TN14 RESPONSE TO FURTHER LHA COMMENT - EMPLOYMENT

VERSION	DATE	PROJECT NUMBER AND NAME	CREATED BY	REVIEWED BY
5.0	06.02.2025	23161 – Buntingford	JD	MG

3. LHA COMMENT AND RESPONSE

Appendix G Drawing showing proposed speed restrictions / signage on A10

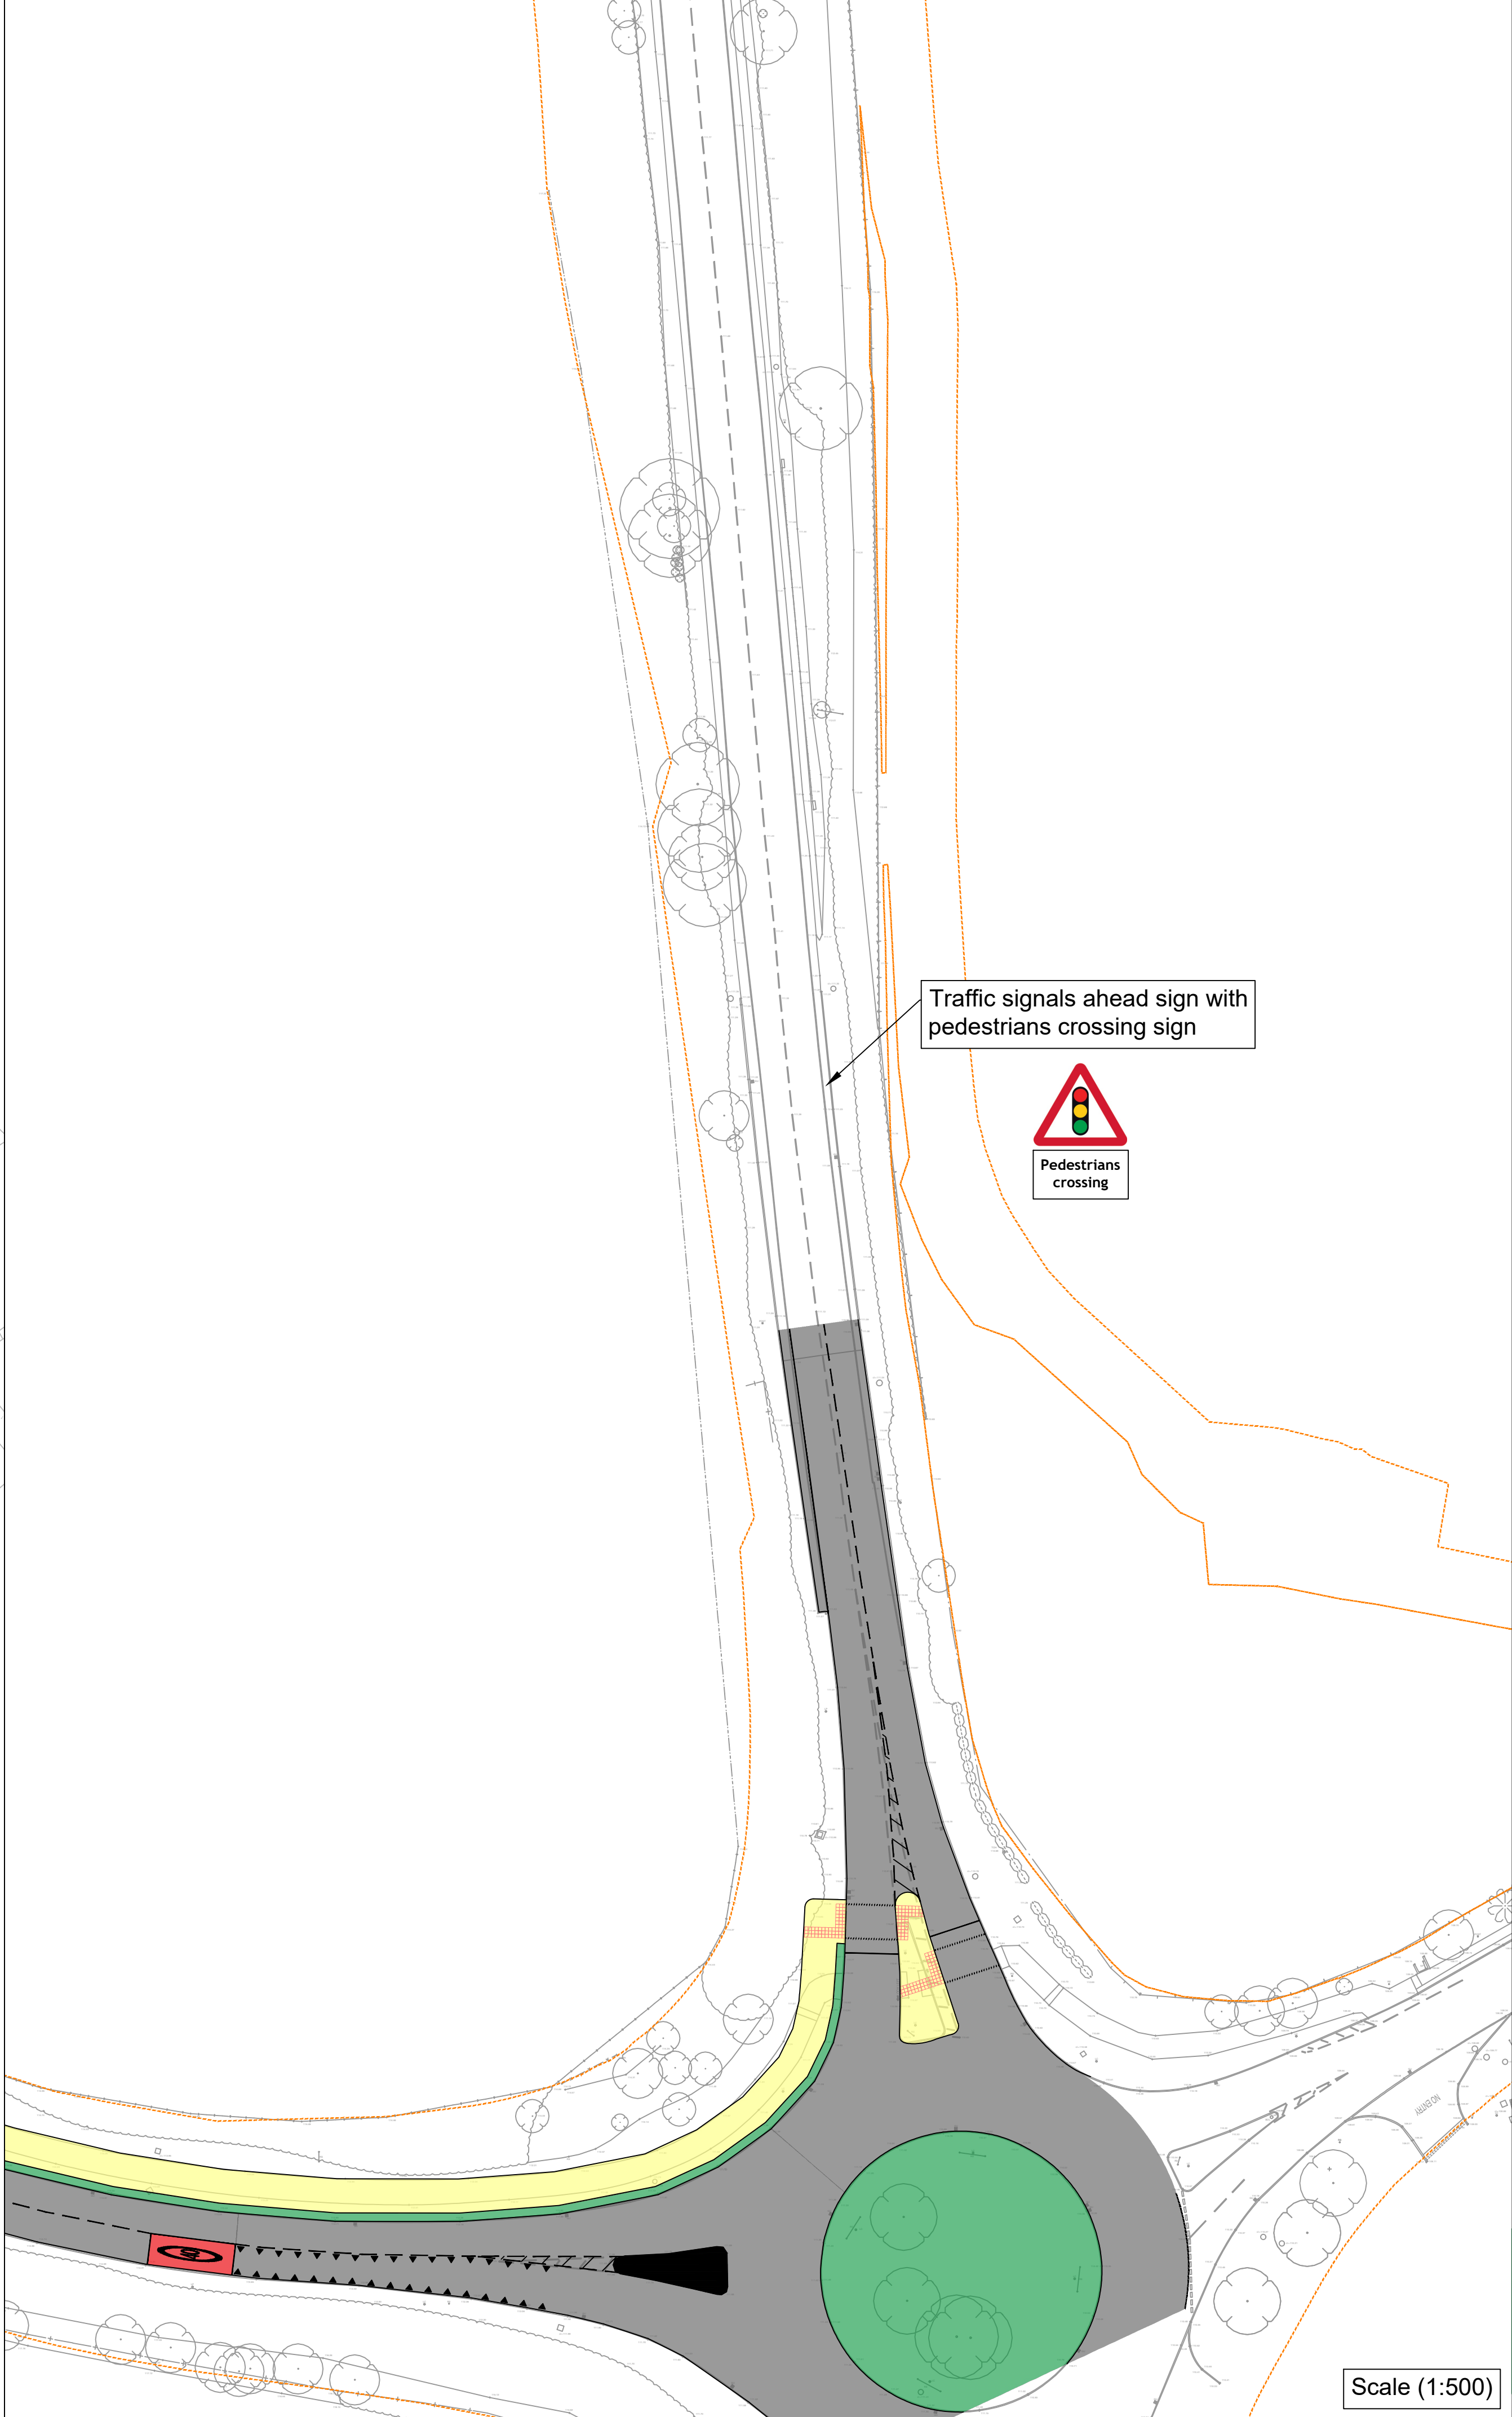
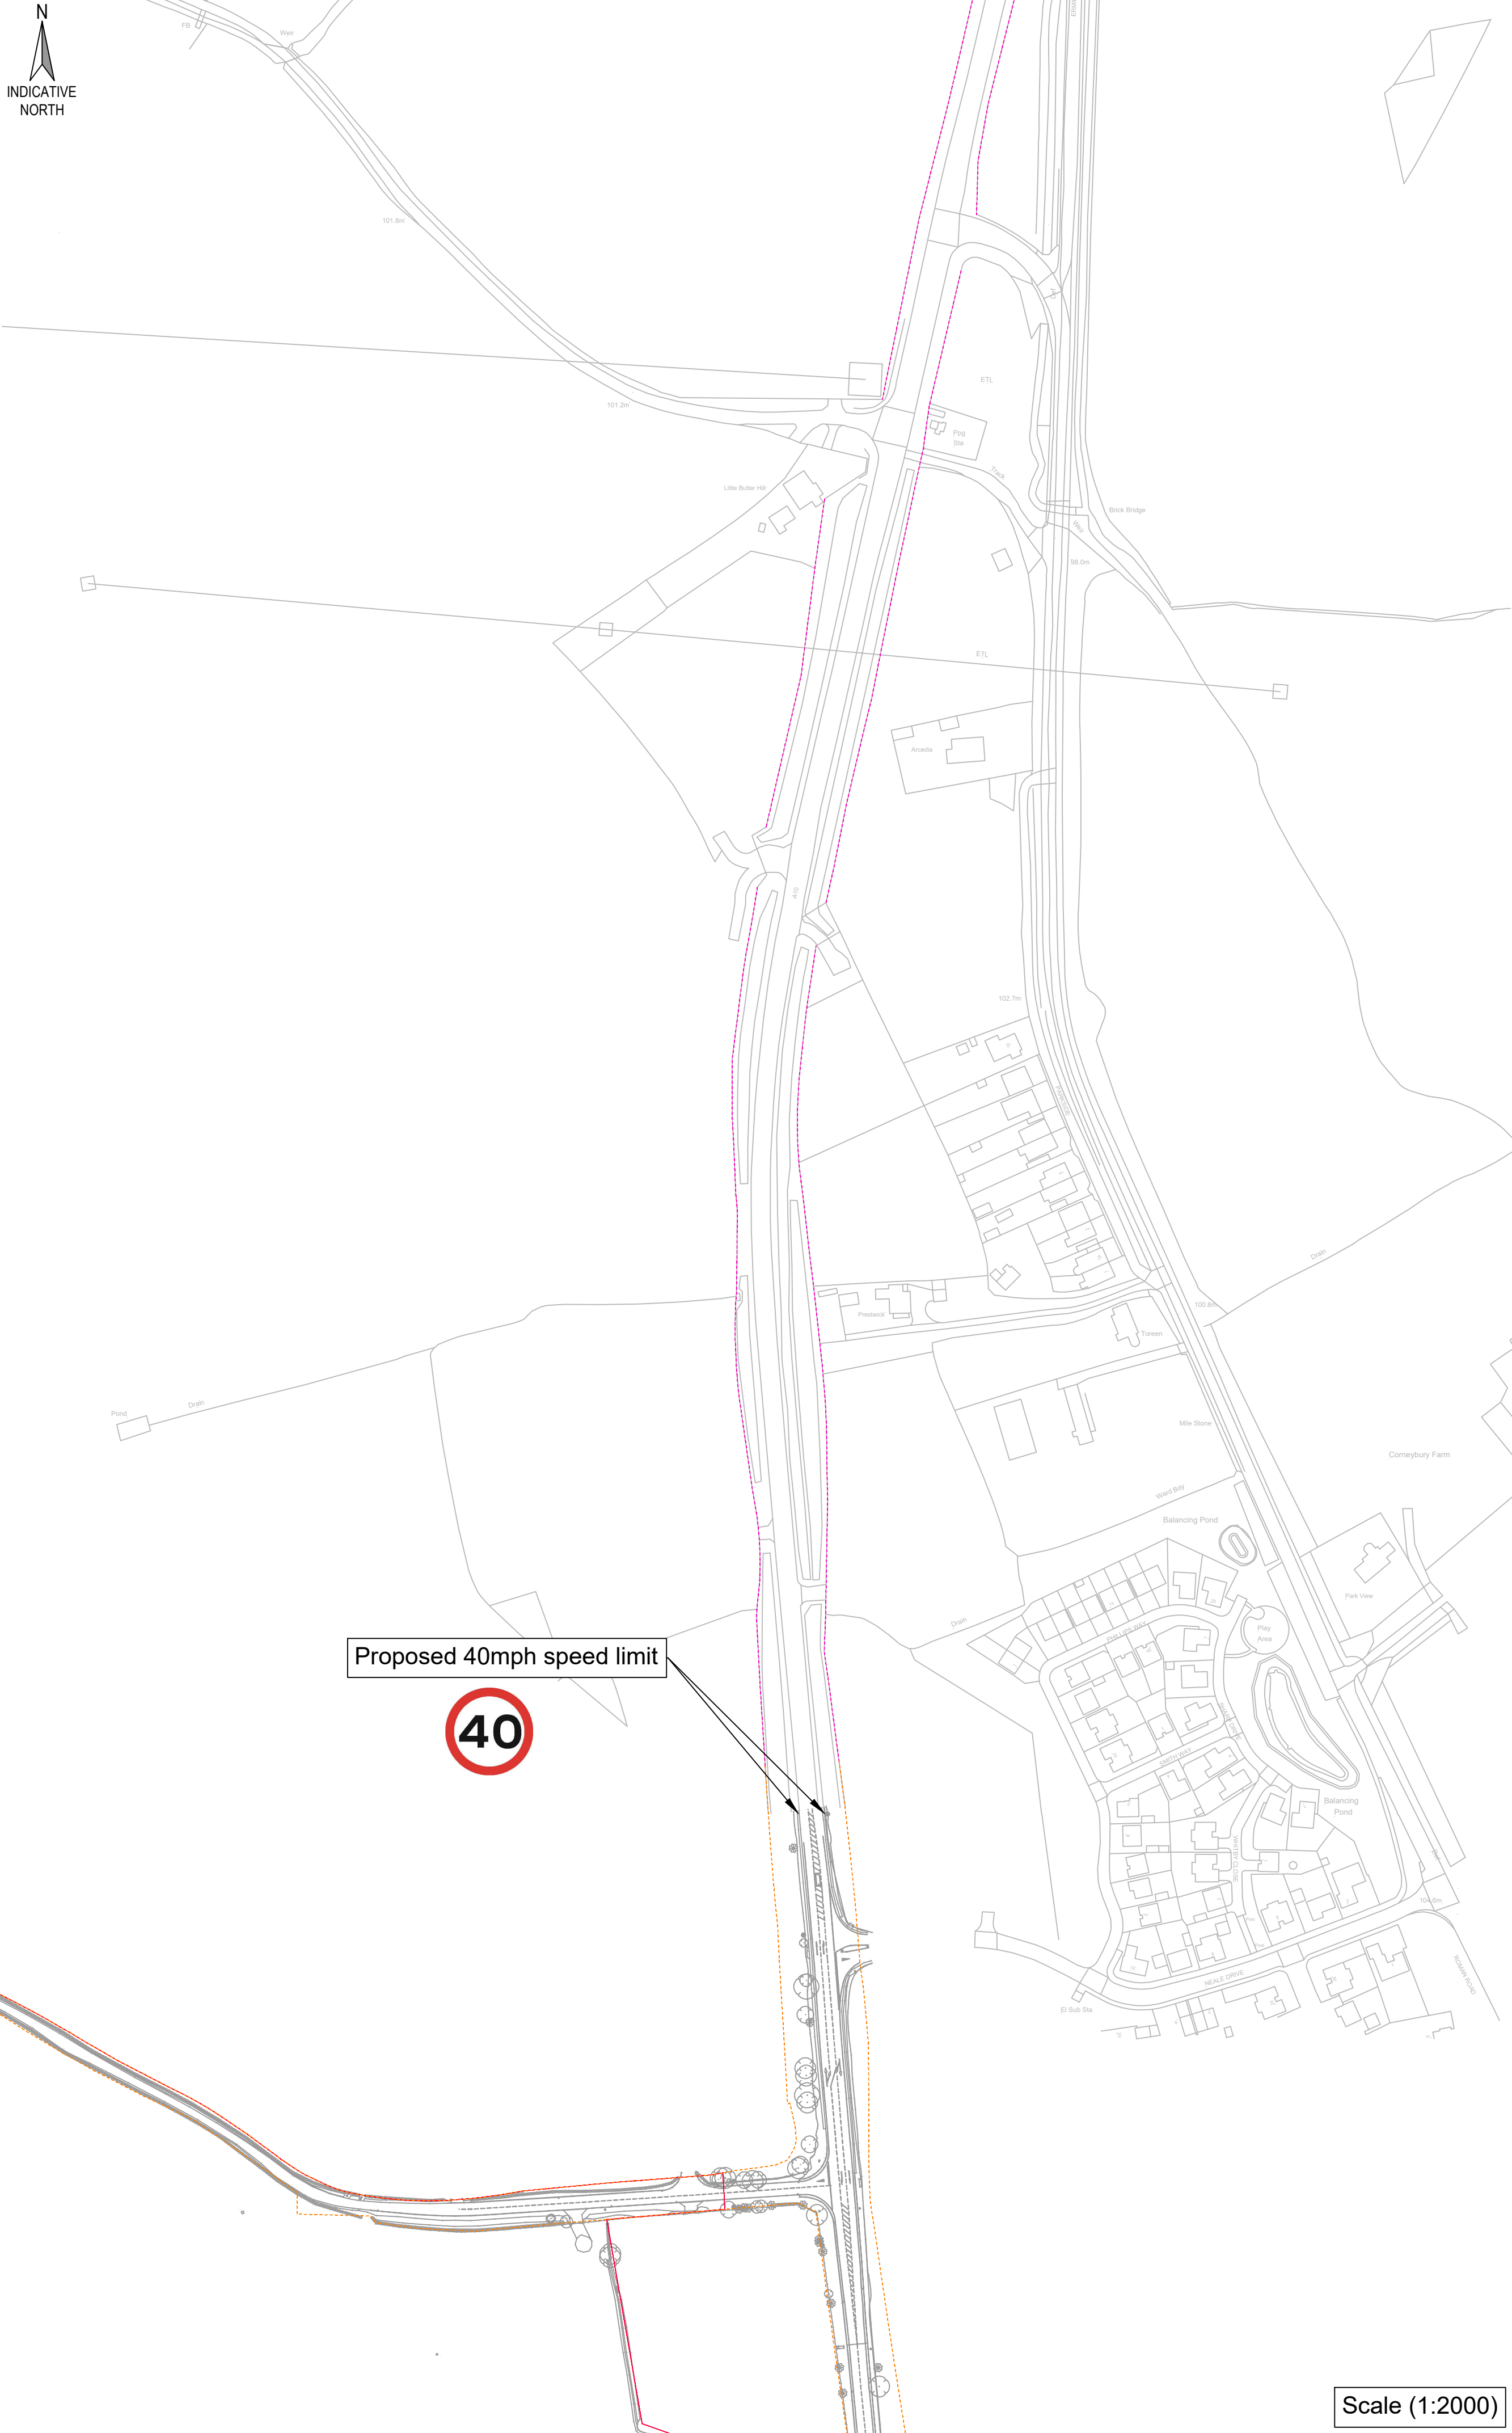
- 3.1.9. As set out in the comment the RSA makes minor design recommendations in relation to the approach to the A10 active travel crossing just north of the Baldock Road roundabout. These include countdown 40mph speed markers and signage providing prior warning of the approach to this crossing. In addition, the audit also recommends positioning the speed limit change further north to separate the driver consideration of speed change and the crossing facility.

- 3.1.10. In this regard it is proposed that the proposed 40mph speed signage at the northern arm of the Baldock Road junction be extended further north to include the Throcking Lane junction. Furthermore, signage is also proposed on the southbound carriageway between the Throcking Lane junction and Baldock Road roundabout to inform drivers of the proposed crossing just north of the Baldock Road roundabout. A drawing showing details of this signage strategy has been included as **Appendix G**.

- 3.1.11. It is noted that speed countdown markers have not been applied given that Chapter 3 (paragraph 8.2.6) of the Department of Transport 'Traffic Signs Manual' specifically recommends against the introduction of this type of signage:
"Countdown" signs giving advance indication of a change in the speed limit are not prescribed and must not be used, unless they have been authorised by the national authority. In England, there is a clear policy not to authorise these signs."
